Arlington High School Building Committee
Finance Subcommittee Meeting
Wednesday, March 16, 2022
Conducted by Remote Participation
4:00 PM – 5:00 PM
Agenda

3/16/2022 AHSBC Finance Subcommittee Meeting Meeting Materials

1. Motion to approve Consigli AHS Requisition #23 for \$1,709,783.89.
2. Motion to approve Change Order No. 12 for a total of \$93,617.67.
3. Motion to approve HMFH/BALA Addition Service Request Change to Natural Gas to Serve Temp Boiler for a total not to exceed value of \$10,450.00.

reference: Drawing A4.3.9

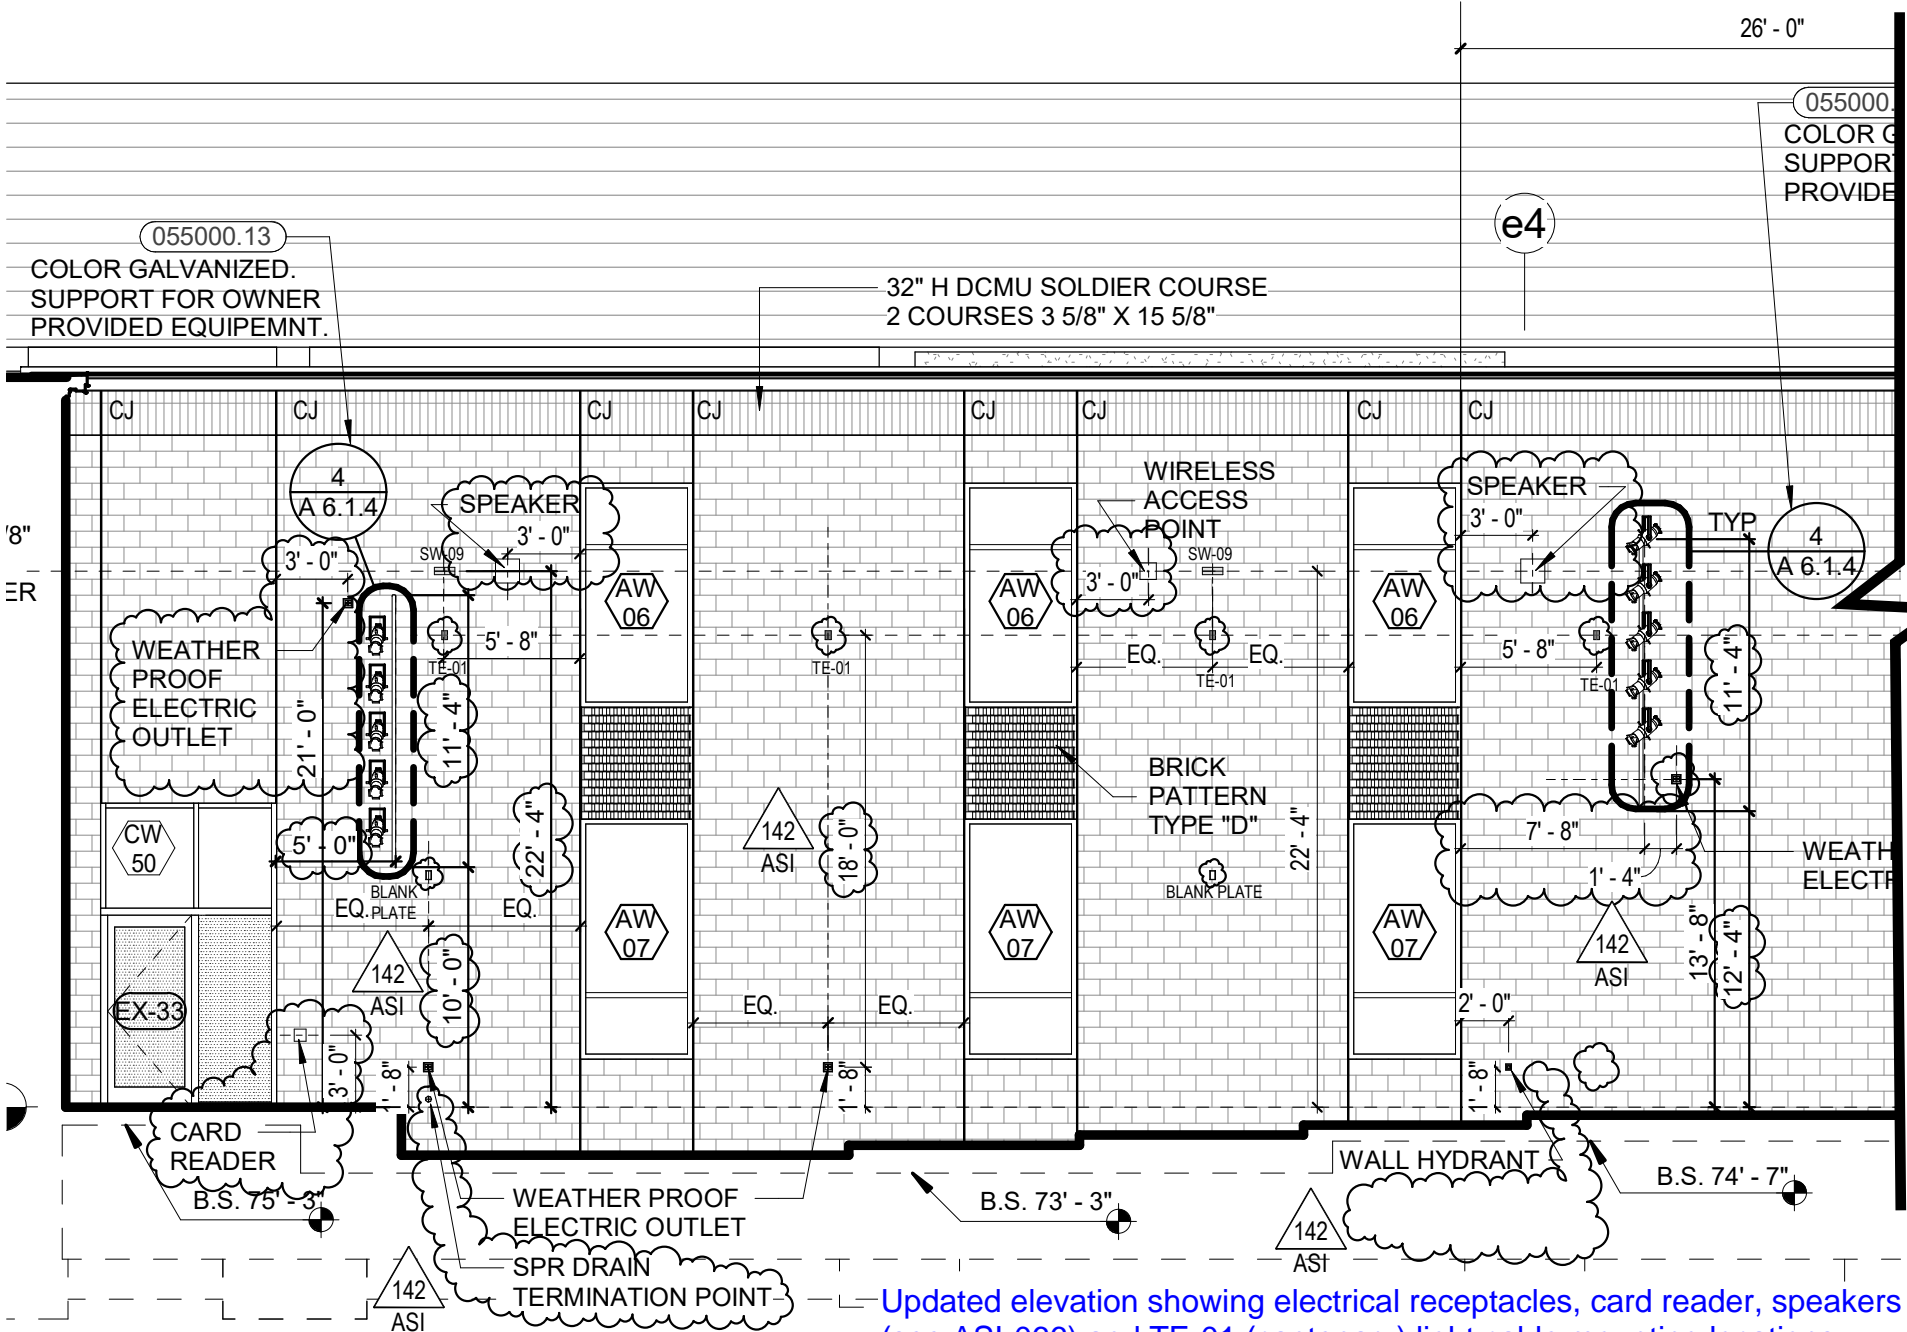
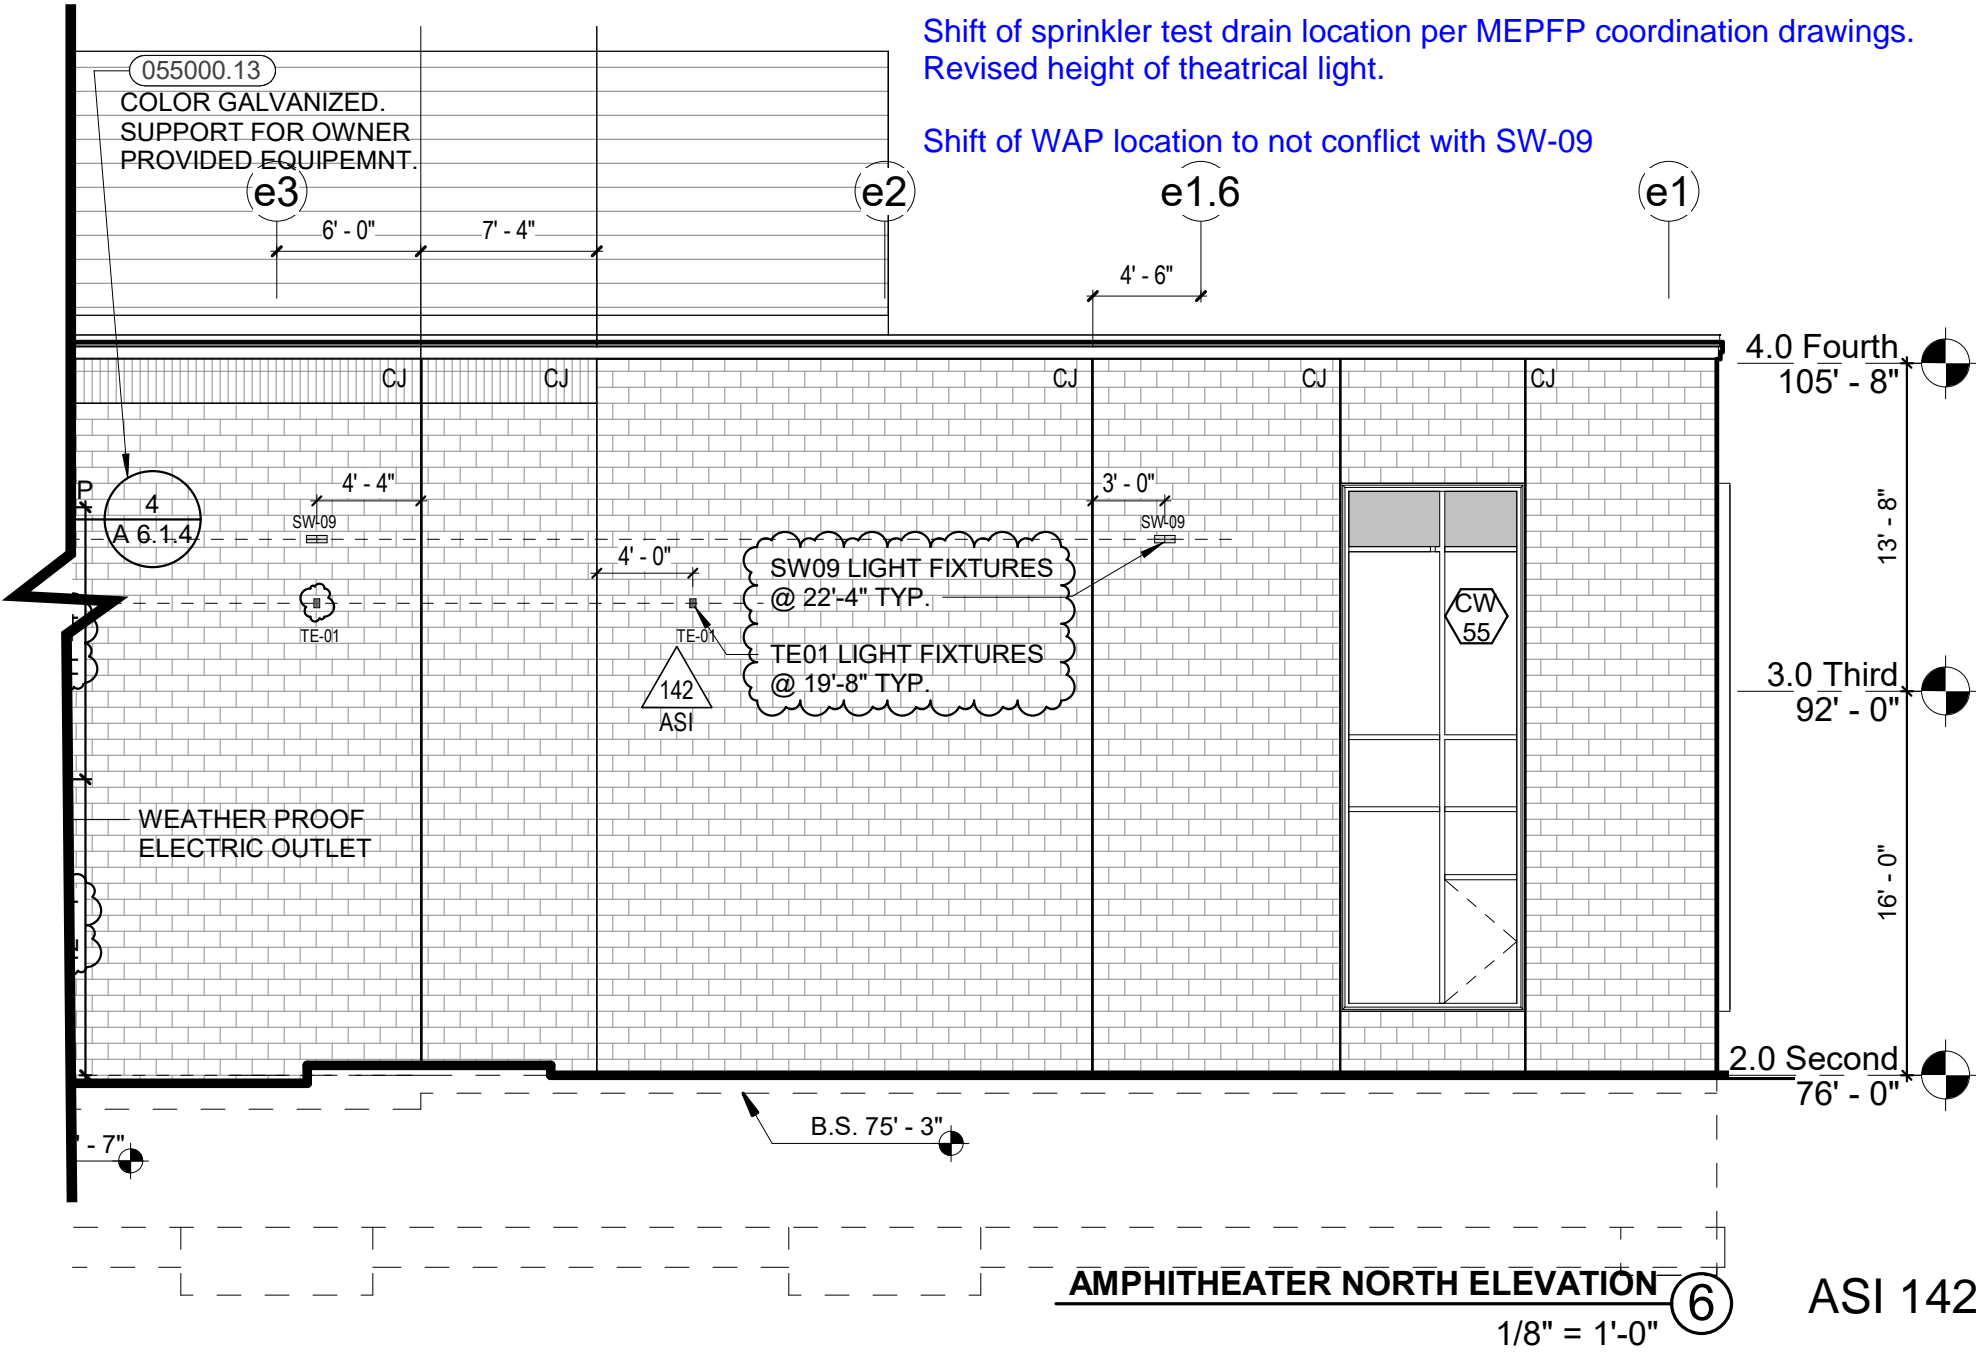
Revision to locating dimensions for items on Exterior Elevation 6/A4.3.9. See sketch SKA-126

UPDATED 08-24-21: SKA-126R issued as follow up per discussion with KS, AD, SM regarding where masonry work had already been installed.

Shift of sprinkler test drain location per MEPFP coordination drawings.
Revised height of theatrical light.

Shift of WAP location to not conflict with SW-09
